## RESPONSE TO REQUEST FOR ADDITIONAL INFORMATION

### APR1400 Design Certification

RAI No.: 391-8462  
SRP Section: 06.02.02 - Containment Heat Removal Systems  
Application Section:  
Date of RAI Issue: 02/01/2016

### **Question No. 06.02.02-38**

Figure 3.8-1 IRWST and Containment Spray pH vs. Time Curve used in Chemical Effects Analysis

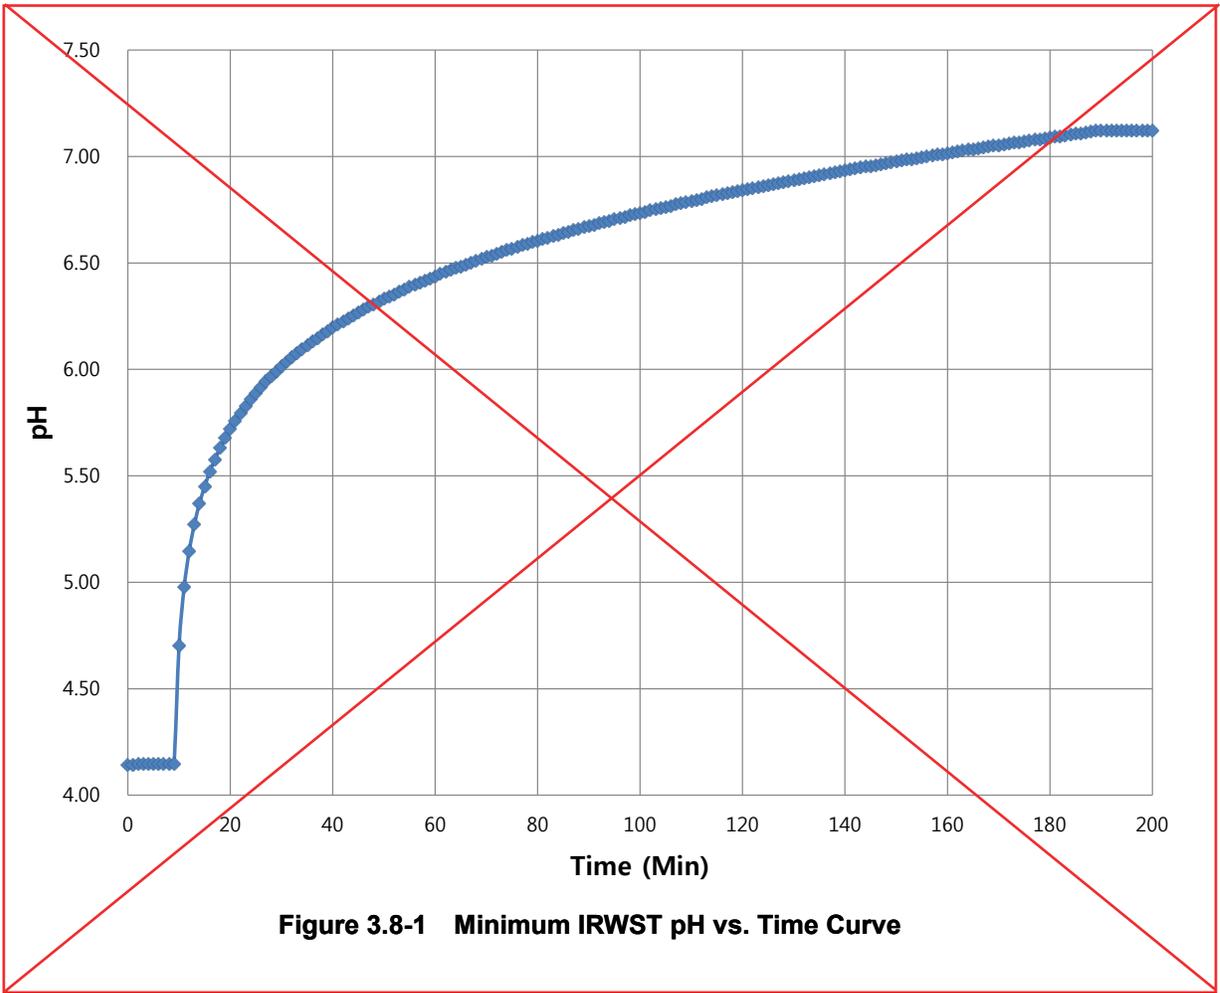
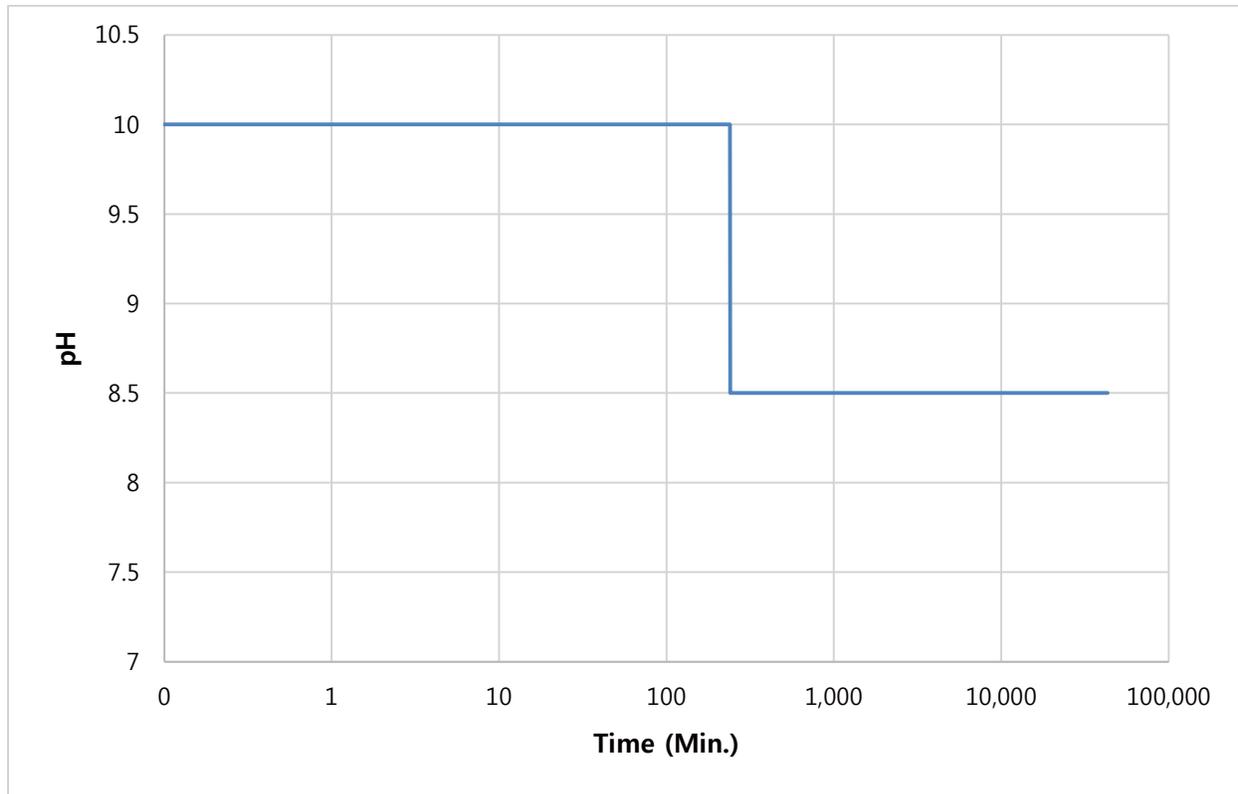
Based on the TR and the November 24, 2015, responses (ML15328A218) to MCB Issues #7 and #8 (KHNP AI 6-19.7 and -19.8), it is the staff's understanding that the APR1400 chemical effects analysis was based on bounding pH values in the WCAP-16530-NP-A methodology. However, the TR includes Figure 3.8-1, "Minimum IRWST pH vs. Time Curve," without explaining how it was used. In order to support the staff's understanding of the APR1400 chemical effects analysis, please describe how Figure 3.8-1 was generated and how it was used in the analysis. Explain whether multiple WCAP-16530-NP-A analysis were performed to compare different pH transients or whether only the bounding analysis in the TR was performed.

This minimum IRWST pH curve is not used in the chemical effects analysis; the bounding pH values (the highest pH values during the short-term and long-term responses, respectively) are used. Figure 3.8-1 of the Technical Report will be replaced with the pH curve used in the analysis and renamed appropriately, as shown in the attachment.

Replaced with A
